Groundwater Transfer Review Summary Form

Transfer/PA # T- 14077

Application: T-14077

Applicant Name: Randall W. and Laura J. Shepard

Transfer Map

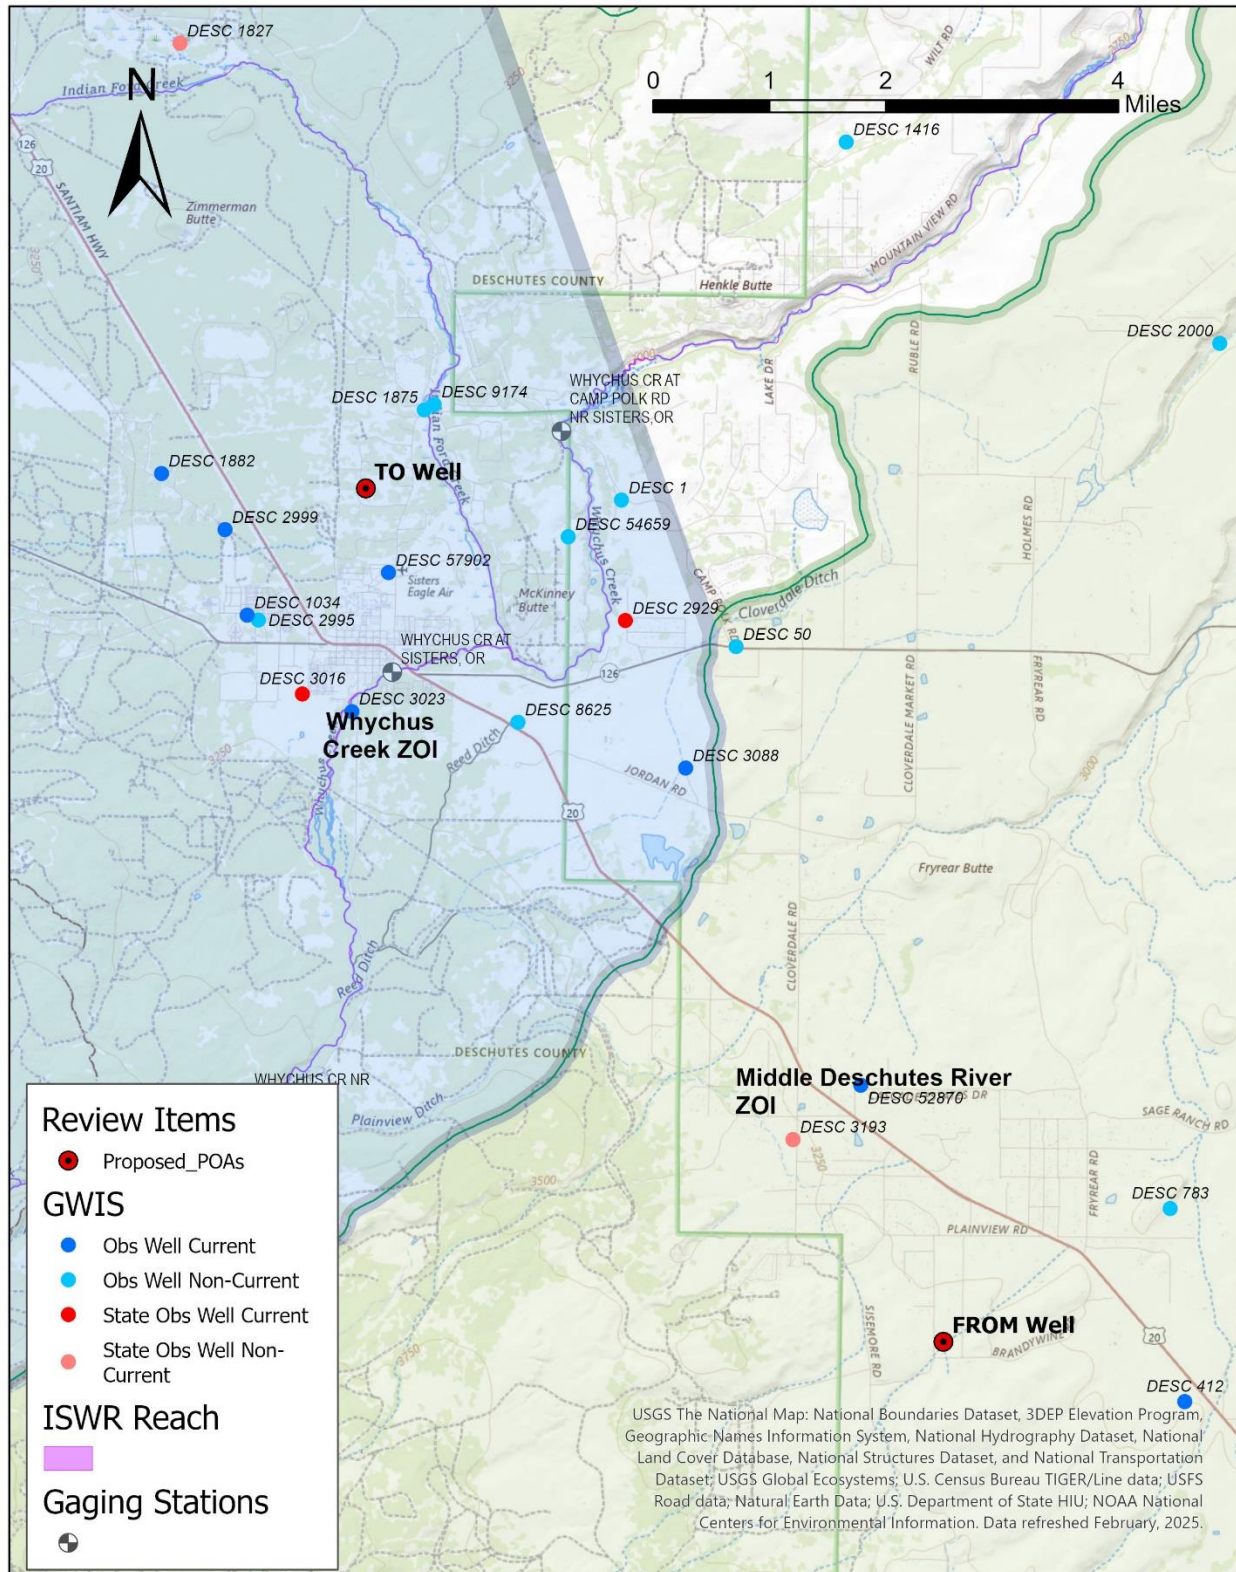
-
1. Basic description of the changes proposed in this transfer: Certificate 95328 authorizes irrigation of 4.19 acres with a maximum rate of 0.052 cfs from a single POA (DESC 52803). This transfer would move 1.5 acres from certificate 95328 to a new POU in TRS 14S/10E-33 and to POA DESC 1906.

2. Will the proposed POA develop the same aquifer (source) as the existing authorized POA?
☒ Yes ☐ No Comments: The applicant included the well log DESC 52849 for the TO Well, which did not include well dimensions, construction, or lithology information. Further research by OWRD staff concluded that DESC 1906 is the original log that corresponds to the address of the TO POA. DESC 1906 is drilled to a depth of 90 feet and accesses ~ 60 feet of Deschutes regional aquifer where it is hosted in unconsolidated glacial outwash sediments in the Sisters area. The FROM well is drilled to 420 feet and accesses the Deschutes regional aquifer where it is hosted in Cascade-sourced tuffs and lavas. Although the wells are more than 8 miles apart, they both access the Deschutes regional aquifer.

4. a) Will this proposed change, at its maximum allowed rate of use, likely result in an increase in interference with **another ground water right**?
☒ Yes ☐ No Comments: The proposed change will increase groundwater pumping at DESC 1906 by approximately 4.5 AF/year. Any increase in groundwater pumpage will increase interference with adjacent wells.

5. a) Will this proposed change, at its maximum allowed rate of use, likely result in an increase in interference with **another surface water source**?
☒ Yes ☐ No Comments: The FROM well is located in the Middle Deschutes Zone of Impact. Pumpage at the FROM well is expected to interfere with the Deschutes River downstream of Lower Bridge where the regional aquifer begins to discharge into the stream.

- The TO well is located within the Whychus Creek Zone of Impact. Multiple seepage runs have documented an increase of ~6 cfs in Whychus Creek from springs along the eastern flank of McKinney Butte. It is 3,600 feet from Indian Ford Creek and 10,000 feet from Whychus Creek where it begins gaining flow from springs along McKinney Butte. Pumpage at the TO well will cause interference with Whychus Creek that would not occur from pumping at the FROM well.

- b) If yes, at its maximum allowed rate of use, what is the expected change in degree of interference with any **surface water sources** resulting from the proposed change?
Stream: Whychus Creek ☐ Minimal ☒ Significant
Stream: NA ☐ Minimal ☐ Significant
Provide context for minimal/significant impact: The stream depletion caused by increased groundwater pumping at DESC 1906 would decrease groundwater discharge to Whychus Creek east of McKinney Butte. This would reduce the time that the instream right on Whychus Creek (certificate 73223) is met.
